PUBLIC HEARING AGENDA REQUEST

March 8, 2007

A Resolution to Deny Colonial Crossing Rezoning REZN05-LE-014; and Special Exception SPEX06-LE-020

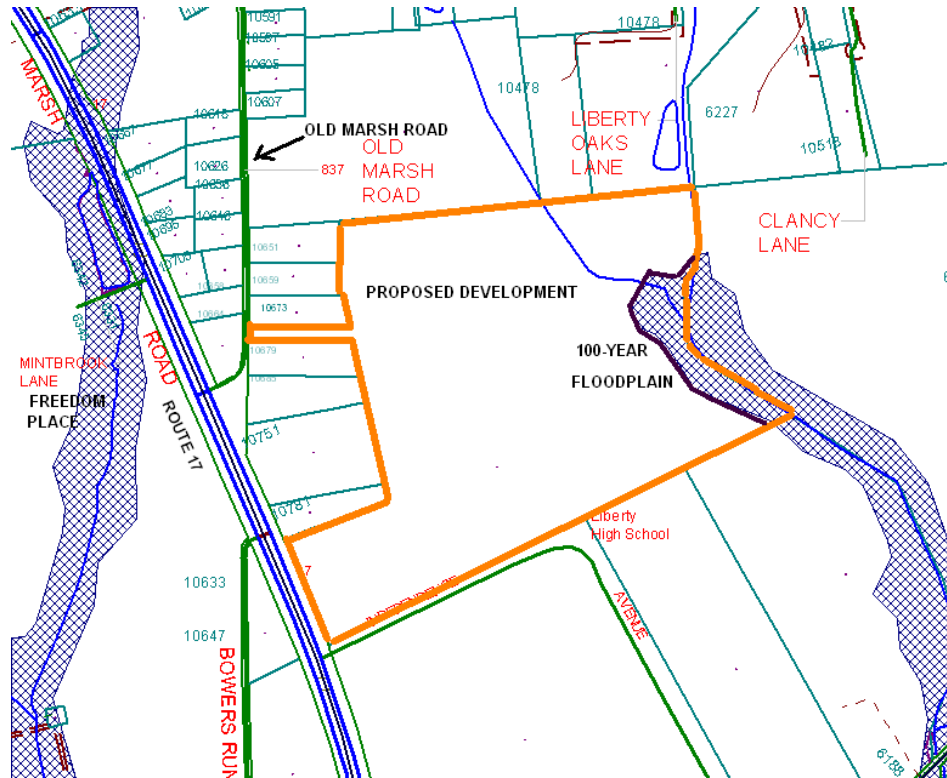
- Provision of the WSA preferred location for the proposed pump station.
- Construction of the pump station to ensure it is large enough to accommodate additional equipment and capacity for the commercial acreage on this parcel (note: commercial is not

part of this rezoning application). Future hook-up of the commercial property should not impact residential community.

- Preliminary floodplain study results assisting in lotting revisions and East-West Connector alignment, as required.
- Proper road alignment of “Colonial Crossing Drive” with the East-West Connector (as shown on the Freedom Place Preliminary Plat).

- Reservation of an area large enough to accommodate a feasible option for road alignment for the East-West Connector (right-of-way for this road requires a minimum of 110 feet), past the point that the applicant proposes to build it (as shown on the CDP).

- Justification for rezoning (per Chapter 6 of the Comprehensive Plan) for a density higher than one dwelling unit per acre (application is closer to 2 units per acre).

- Modifications to the buffer adjacent to the portion of the parcel designated for commercial to allow for preservation of environmental features.
- Incorporation of a phasing plan for the development.

- Consideration of the current proffer policy (Note: facilities impacts and voluntary proffer contributions {approximately \$28,000 per unit under current proffer policy} exclusive of transportation impacts).

- Incorporation of Low Impact Development (LID) principles – relocation of lots, flood easements, and house setbacks from floodplain (25-foot requirement).

- Inclusion of note on plat, per County Engineer, regarding basements not recommended in soil mapping units with high shrink swell potential.
- VDOT acceptance of the Traffic Impact Analysis and the proposed roadway improvements.

- Refinements to the proffer statement to address any project revisions.
